April 27, 2010

EPA-SAB-10-006

Subject: SAB Review of Empirical Approaches for Nutrient Criteria Derivation

Figure 1. EPA's Framework for Developing Nutrient Criteria Based on Stressor-Response Relationships and SAB Recommendations for Revision

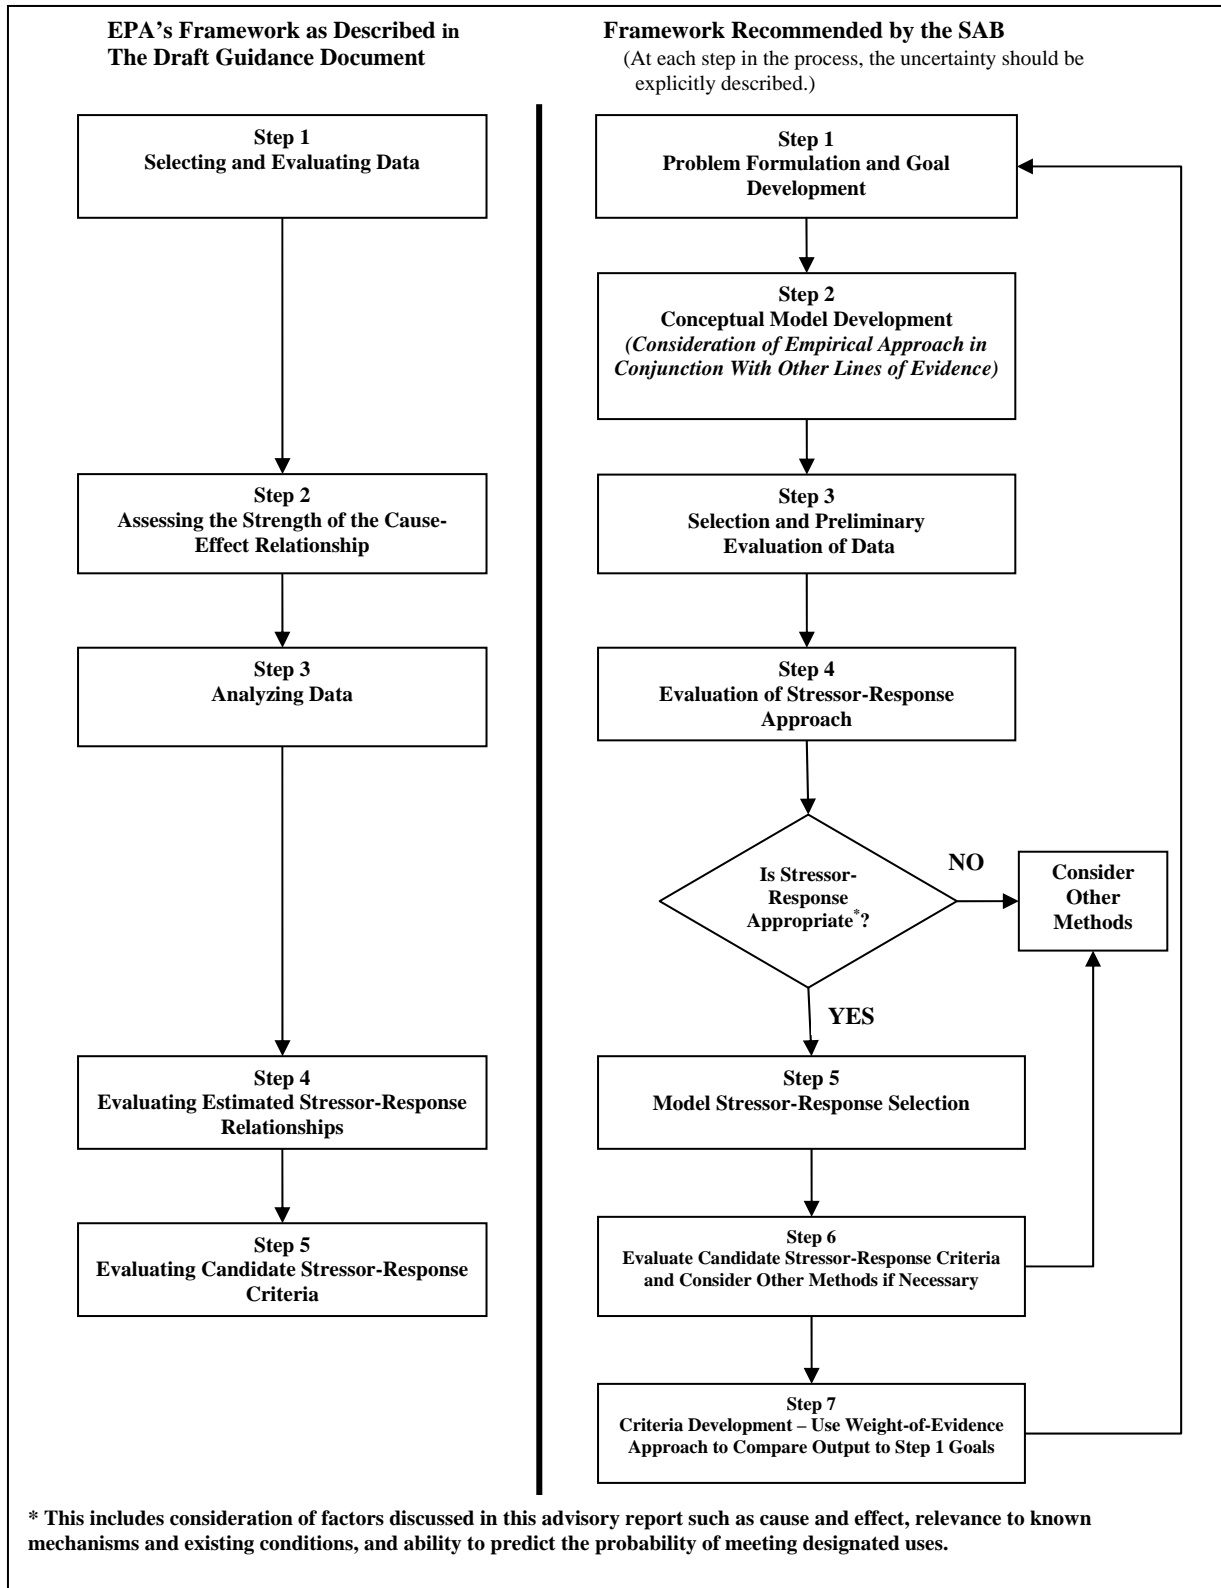
- The Committee finds that the Guidance: 1) should provide a more specific and descriptive framework outlining the steps in the criteria development process (Figure 1 of this advisory report illustrates EPA's proposed framework for developing nutrient criteria and the SAB recommendations for revision of the framework); 2) must be detailed and sophisticated enough to ensure statistical rigor, but additional support must also be provided by EPA to help users meet the technical demands of the methods; 3) should more clearly express the caveats and limitations of the statistical methods and approaches in the document, in particular the fact that statistical correlations do not establish cause and effect; 4) should contain more technical guidance and examples to describe when and how to use various methods and approaches; and 5) should provide additional guidance on data requirements for application of the statistical methods and approaches.

Figure 1. EPA's Framework for Developing Nutrient Criteria Based on Stressor-Response Relationships and SAB Recommendations for Revision

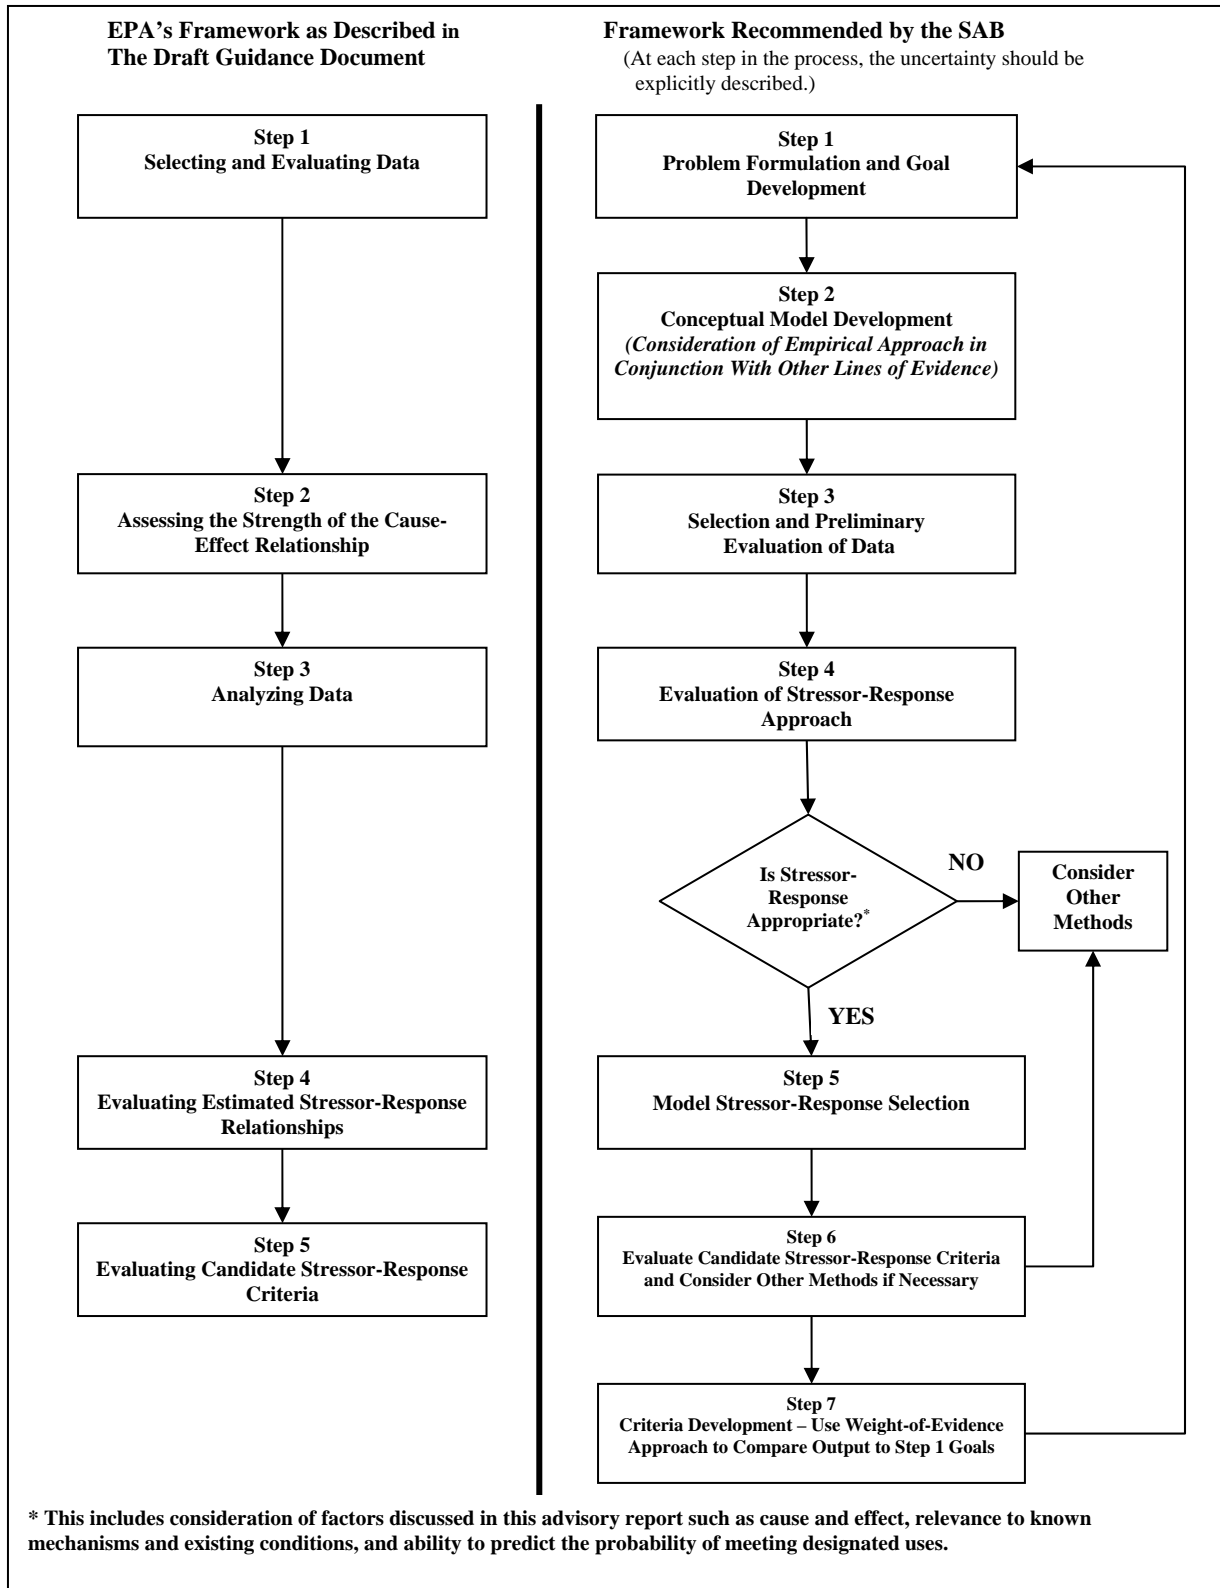
2. EPA should more clearly articulate how the Guidance fits within the decision-making and regulatory processes and, specifically, how it relates to and complements EPA's nutrient criteria technical guidance manuals and other EPA technical documents. Outlining the fundamental principles that underlie the use of stressor-response relationships and providing background information on water quality impairments (e.g., causes and types of impairments, types of designated uses) might provide a useful context. Including a clearer description of how water-use designations influence the derivation of empirically-derived nutrient criteria might be considered as well. Considering the number and usefulness of other EPA-developed processes and recommendations, the authors should consider how they might improve the integration of this document with other EPA efforts. For example, the Guidance would benefit by incorporating the problem formulation stage that is part of the Ecological Risk Assessment process (see Figure 1 of this advisory report).

9. EPA should consider modifying the steps that provide the framework of the Guidance. The Committee suggests that the steps in the framework should be more specific and descriptive. An example is illustrated in Figure 1 of this advisory report. Two important aspects of the example in Figure 1 currently are missing from the Guidance: problem formulation/goal development and conceptual model development should be the first steps in the process, and the framework should contain an explicit step to determine whether the stressor-response relationship is appropriate.

- Conceptual model development should be required and should be incorporated early in the process of criteria development (see Figure 1 of this advisory report). Conceptual models are an important component in selection of response variables. Any stressor-response relationship used in criteria development must have ecological relevance (based on ecological understanding of the system) that can be readily explained and defended as discussed in step two in the Guidance. Conceptual models based on past empirical and experimental studies are important for identifying the mechanisms responsible for responses and effectively communicating this linkage. In the framework suggested by the Committee (Figure 1), developing the conceptual model is the second step in the process. [See the responses to Charge Questions 4 and 6 for additional discussion.]
